Product Change Notification / SYST-28ZNPW394

ERRATA - PIC18(L)F24/25K40 Family Silicon Errata and Data Sheet Clarification Revision

PIC18(L)F24/25K40 Family Silicon Errata and Data Sheet Clarification

Figure 1. 28-pin SPDIP, SSOP, SOIC

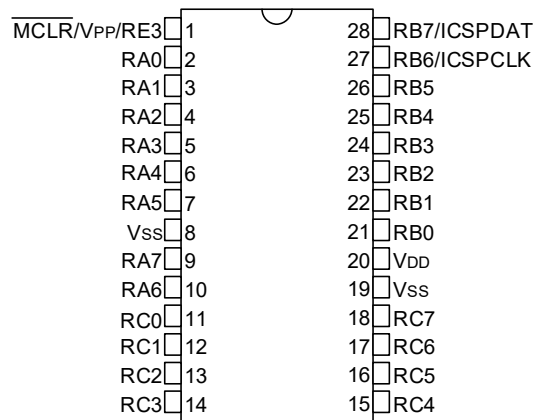
3.1.1 28-pin SPDIP/SSOP/SOIC Pin Diagram

The correct marking for pin 26 on the 28-pin SPDIP/SSOP/SOIC package is **RB5**.

Figure 38-10: ADC Conversion Timing (ADC Clock F_{OSC}-Based)

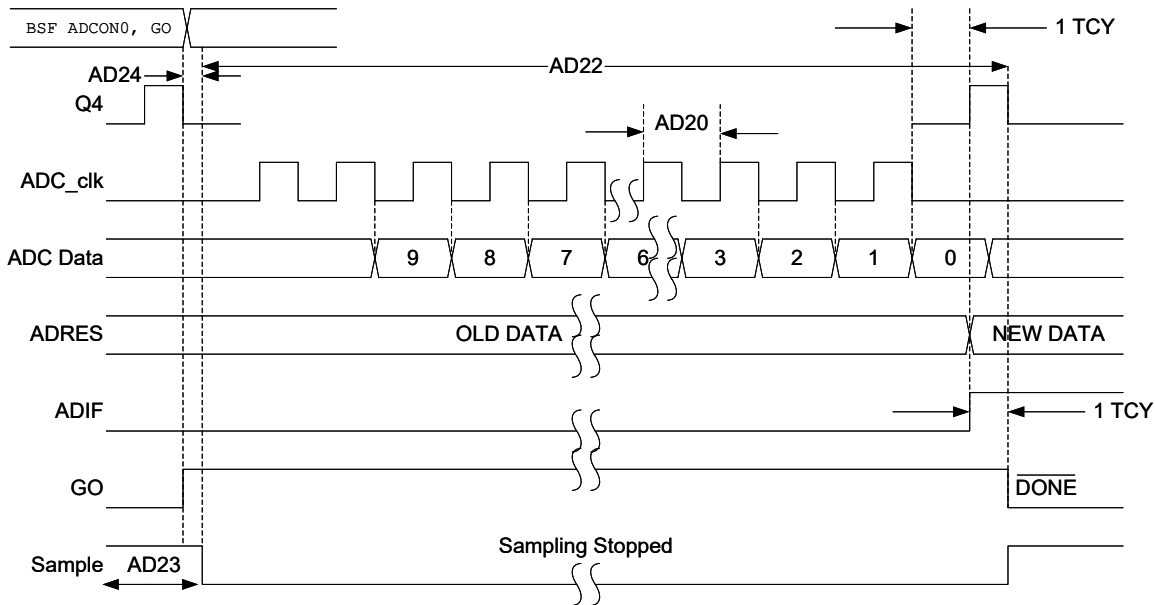
3.2.2 ADC Conversion Timing Diagram

Refer to the images below for corrections of Figure 38-10 and Figure 38-11. Previously, the parameter numbers were incorrect.
